APPEAL SUMMARY

Appeal ID: 18782	Project Address: 111 SW Naito Pkwy
Hearing Date: 12/19/18	Appellant Name: Sara Ruzomberka
Case No.: B-005	Appellant Phone: 503-896-5360
Appeal Type: Building	Plans Examiner/Inspector: Gail Knoll; Megan Sita Walker
Project Type: commercial	Stories: 4e Occupancy: B Construction Type: III-B
Building/Business Name:	Fire Sprinklers: Yes - under canopy
Appeal Involves: Erection of a new structure	LUR or Permit Application No.: 18-255157-LU
Plan Submitted Option: pdf [File 1]	Proposed use: Screening and Protection of trash/recycling and mechanical equipment.

Re: Land Use Review LU 18-255157 HR – Smith Block Enclosures, Mechanical Unit, and Awnings

FLOOR PLANS &
ROOF PLAN

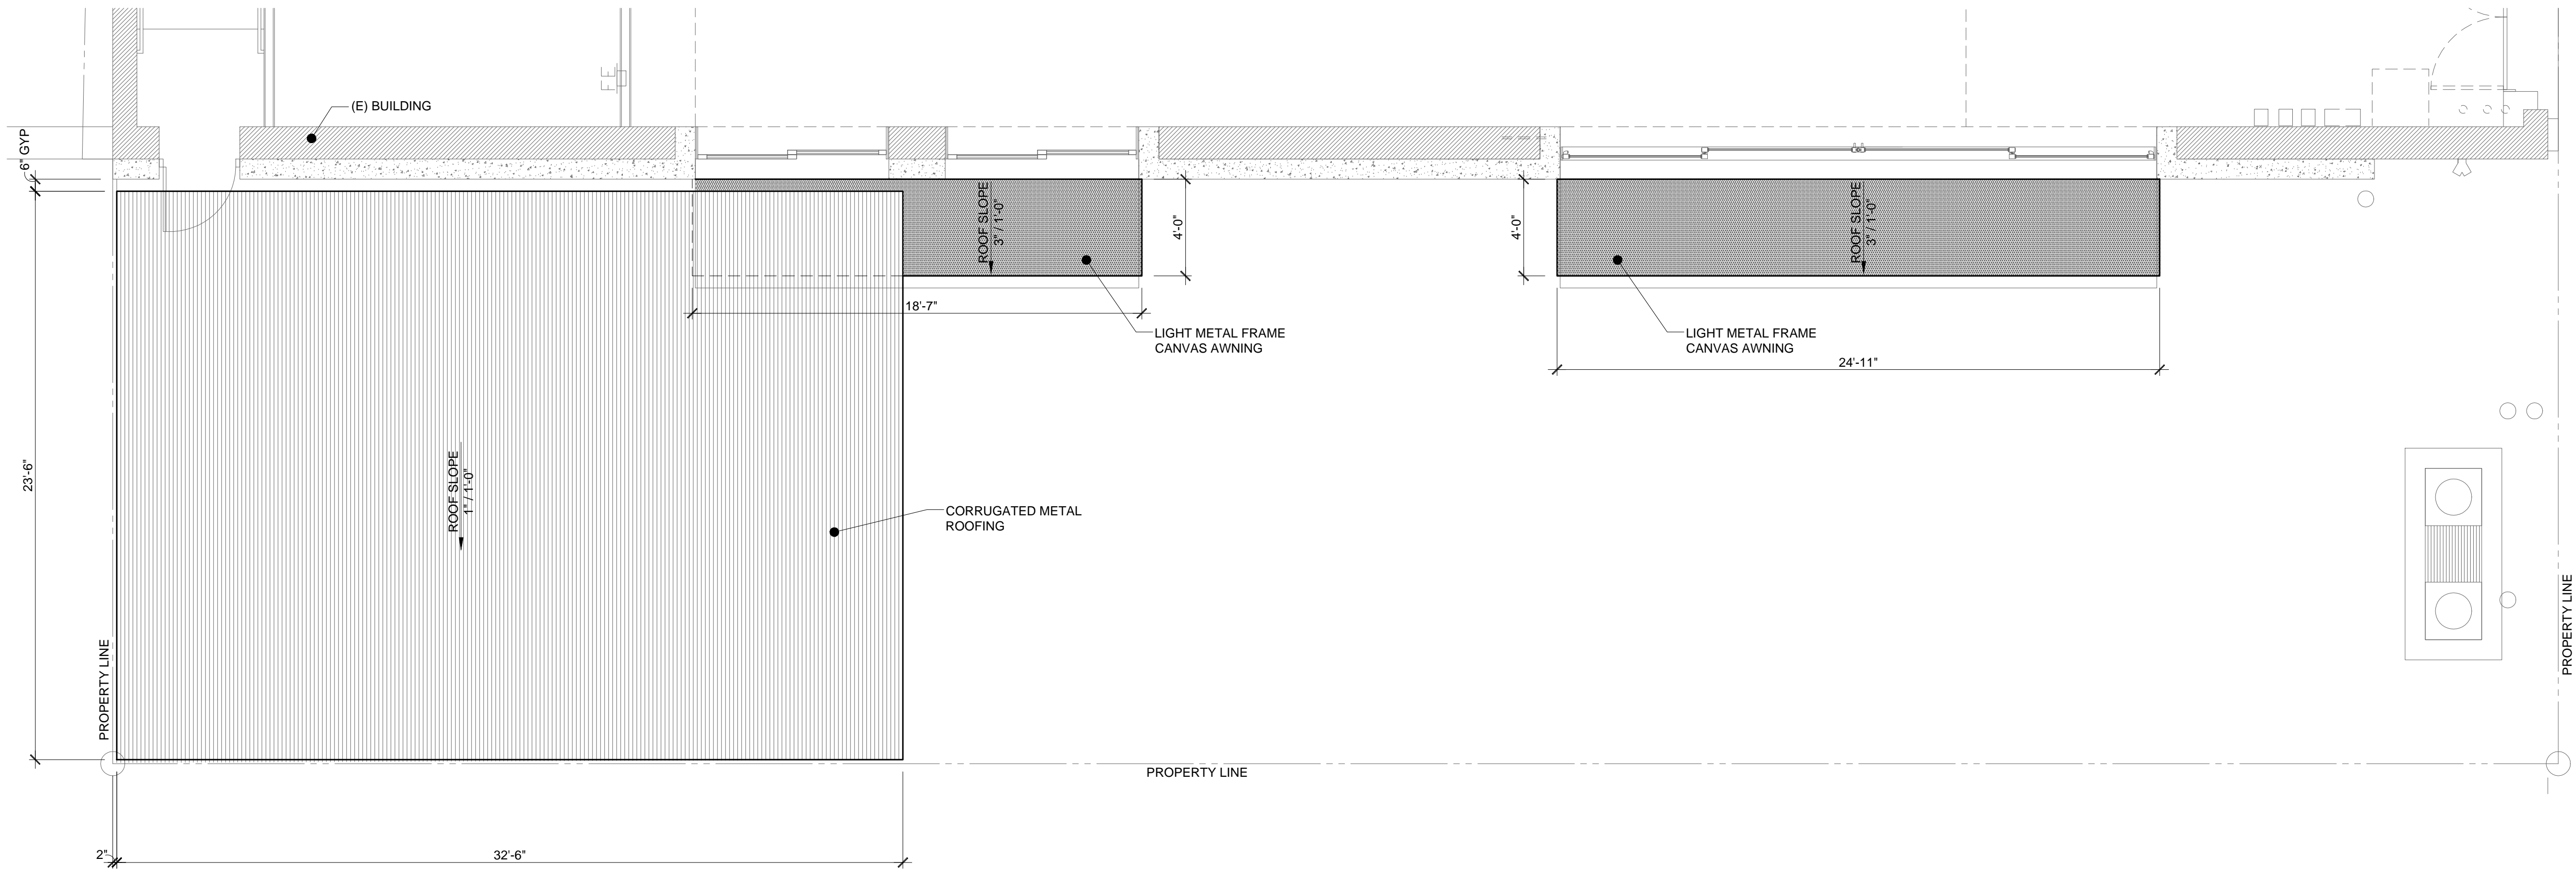
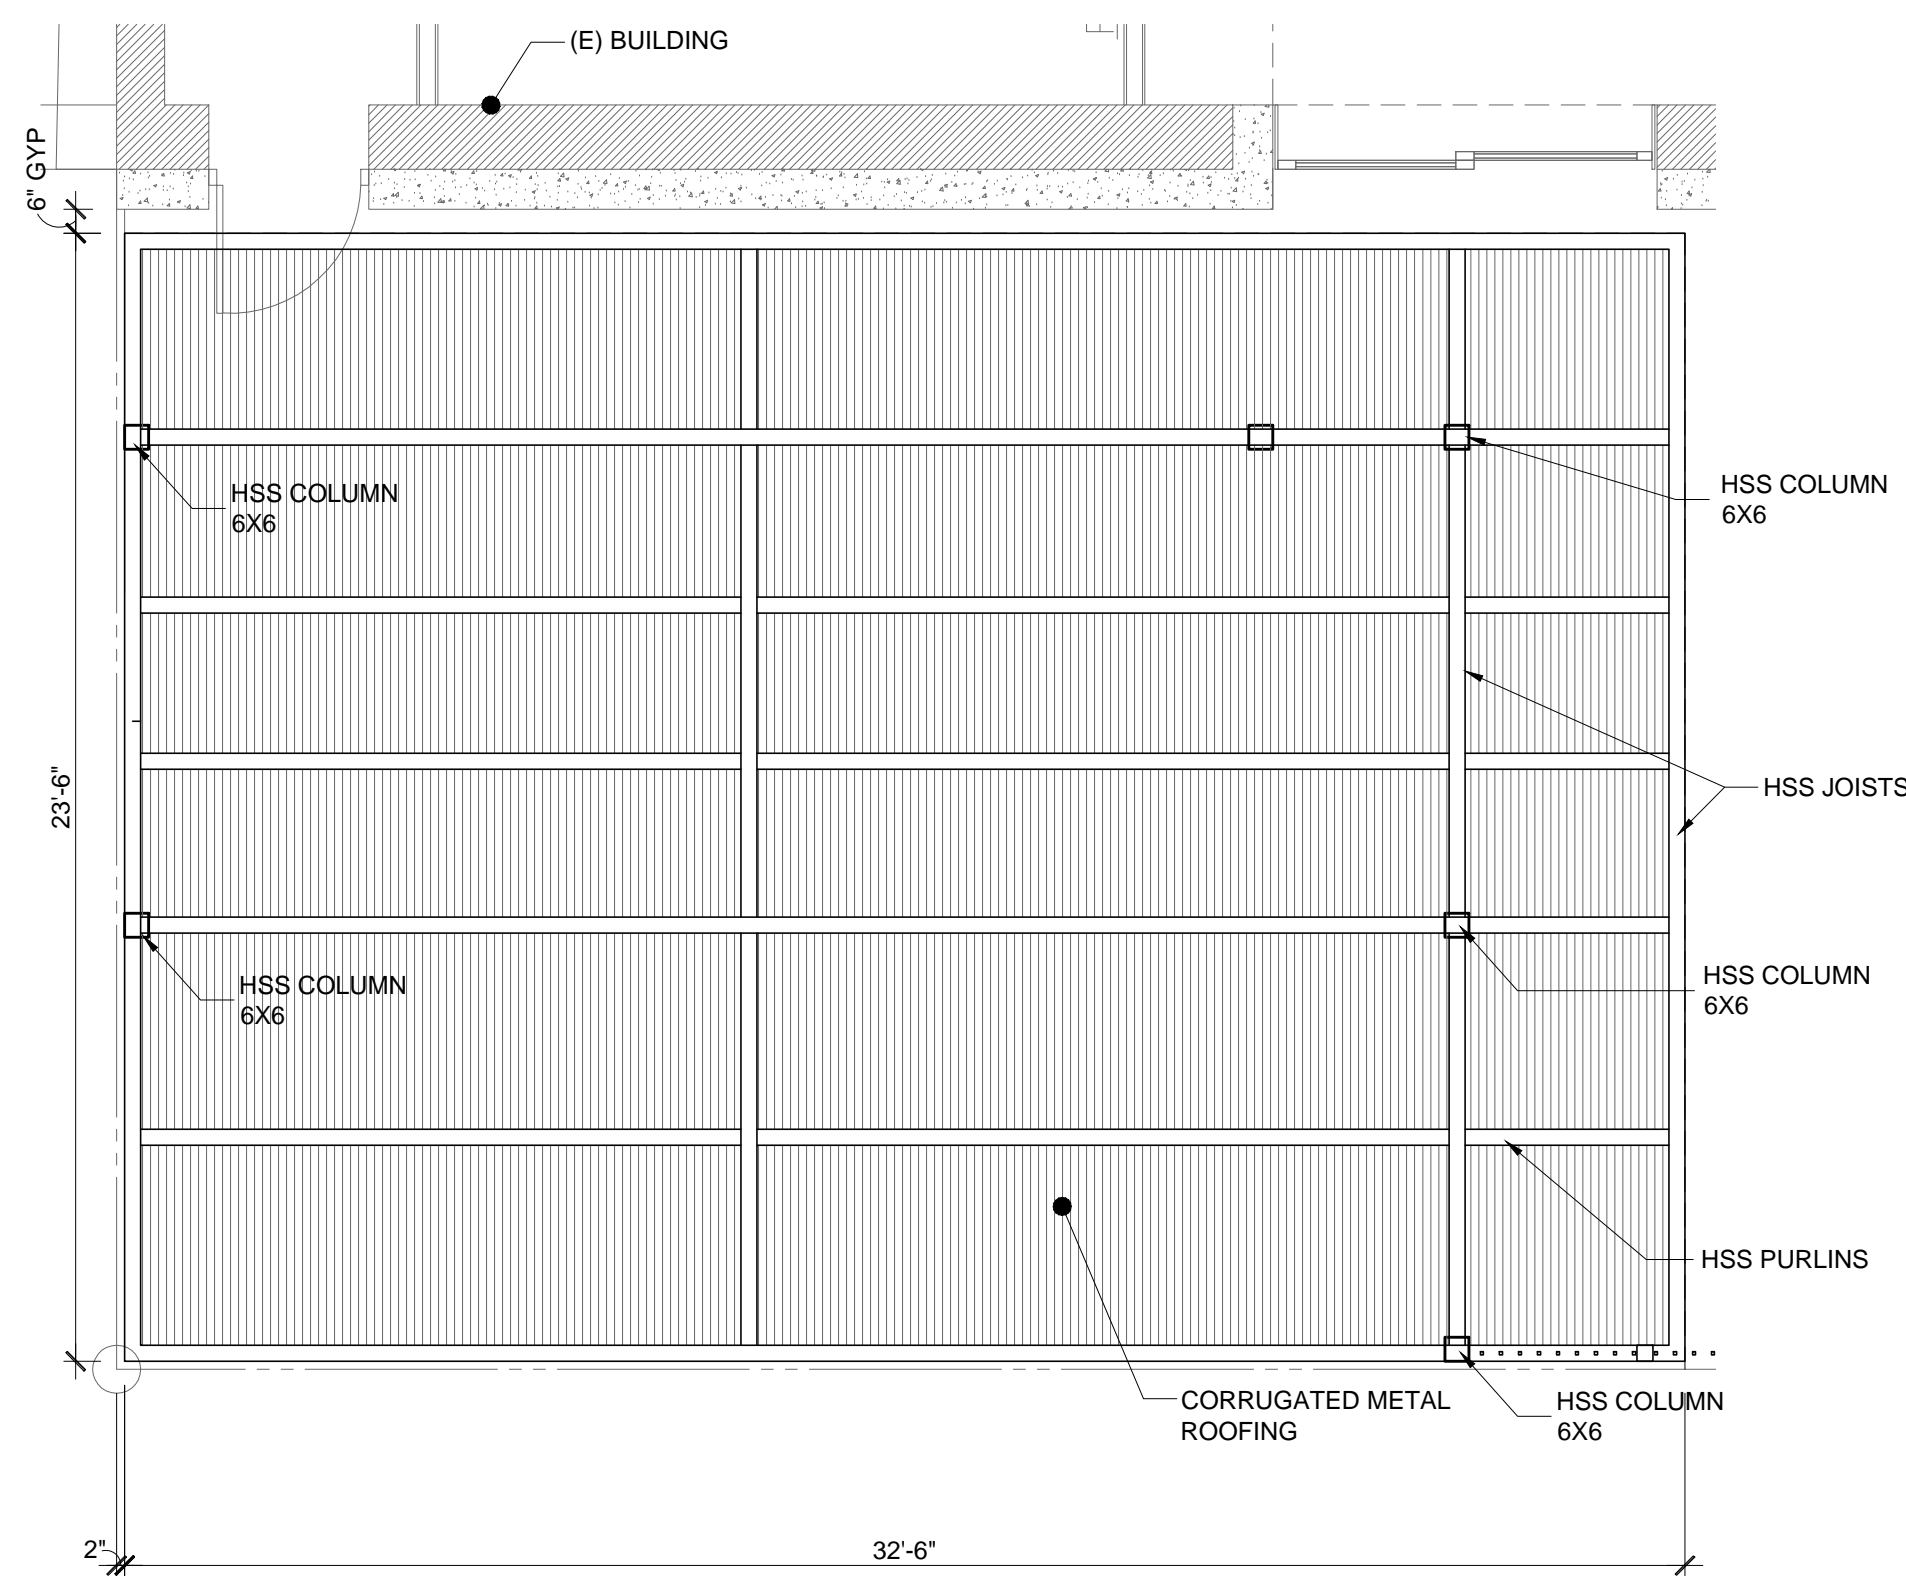
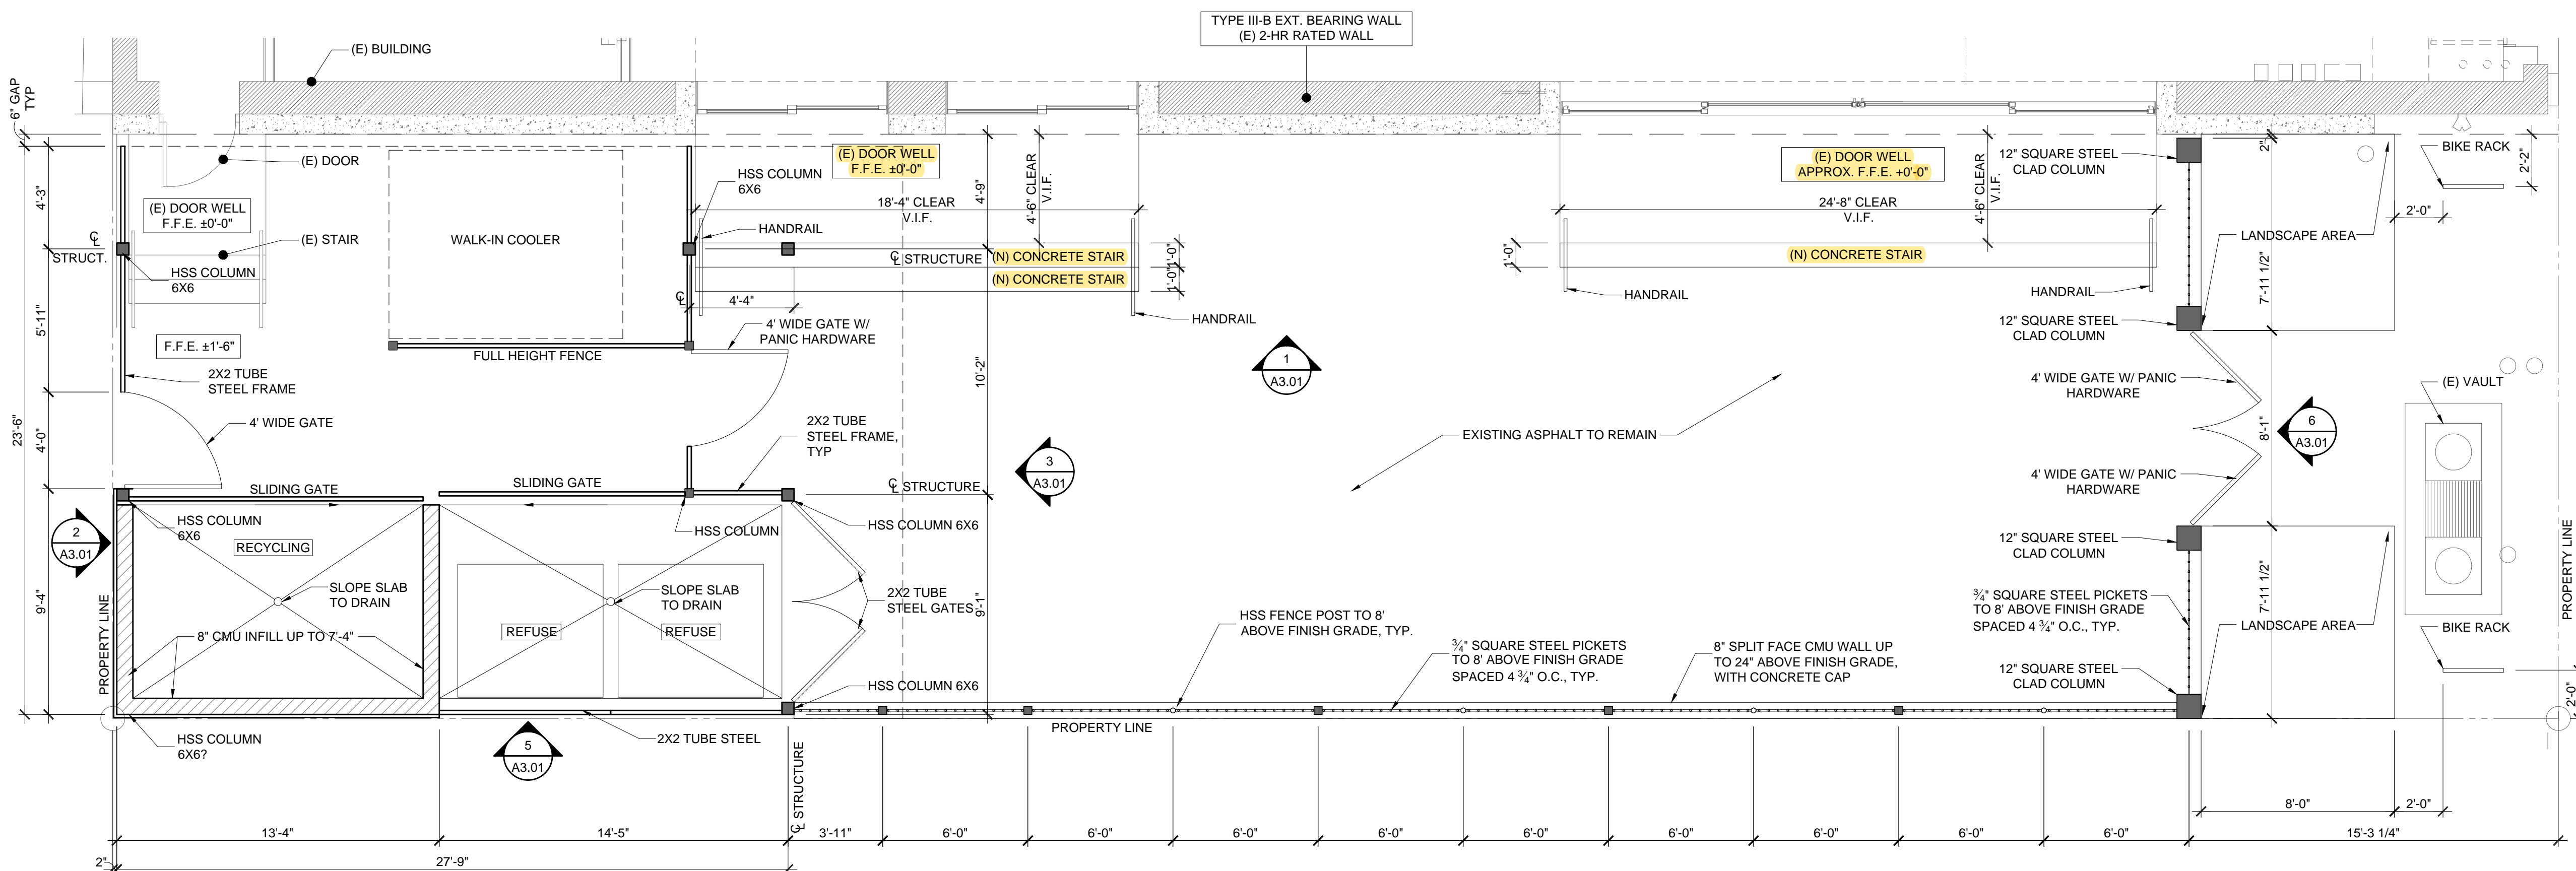
Code Section	OSSC 1104.2
Requires	At least one accessible route shall connect accessible buildings, accessible facilities, accessible elements and accessible spaces that are on the same site.
Proposed Design	Refer to attached sheet A1.01 and A2.01. The project proposes connecting the existing window wells on the south façade of the existing Smiths' Block building, to the unoccupied egress court, with 1 to 2 steps.
Reason for alternative	<p>In our Preliminary Life Safety Meeting, Gail Knoll stated that we would need an accessible ramp connecting each window well to the egress court, but cited no building code section stating such requirement.</p> <p>For this appeal, we cite OSSC section 1104.2 which states at least one accessible route shall connect accessible buildings, accessible facilities, accessible elements and accessible spaces that are on the same site. The southern tenant space containing the window wells is accessible to the egress court through its accessible entry on the east façade, and through the accessible east facing gates in our proposed design. The route is short and realistic. The proposed steps from the window wells are merely a convenience. We find no code section stating the requirement for the added ramps.</p>

2. Omission of ramp at proposed exterior stairs: Denied. Proposal does not provide equivalent Life Safety protection.
